Subject: River Bend Station
Docket No. 50-458
License No. NPF-47
Response to NRC Request for Additional Information Regarding
Proposed Amendment to Revise Reactor Vessel
Pressure/Temperature Limits (TAC NOS. MB1114 and MB1153),
LAR 2000-26

Response to NRC Request for Additional Information Regarding Proposed Amendment to Revise Reactor
Vessel Pressure/Temperature Limits (TAC NOS. MB1114 and MB1153), LAR 2000-26

Response to Request for Additional Information

Figure 5-10. P-T Curves A, B, and C up to 32 EFPY

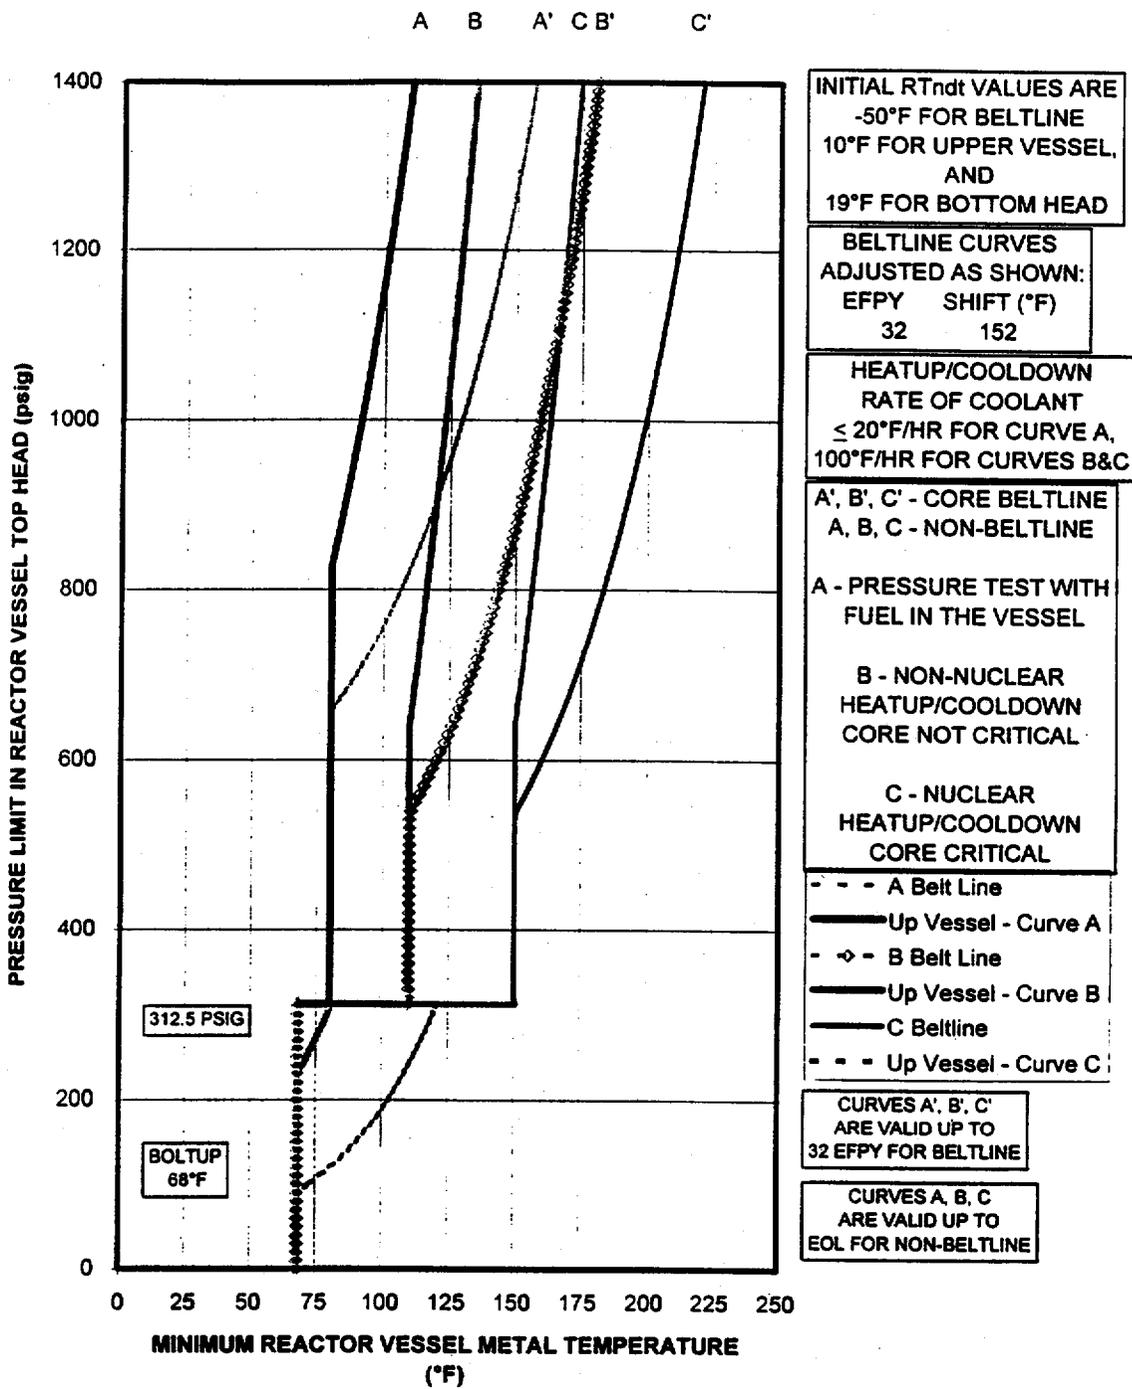
Page 57: The P/T limit curve for the core beltline B' was missing in Figure 5-10. Please provide a complete Figure 5-10.

The P/T limit curve for the core beltline B' was included in the final report as issued (The correct values are listed in Table 5-10). The line is difficult to see due to the coloring/shading of the line. A revised Figure 5-10 (page 57) is attached with the P/T limit curve for the core beltline B' clearly marked.
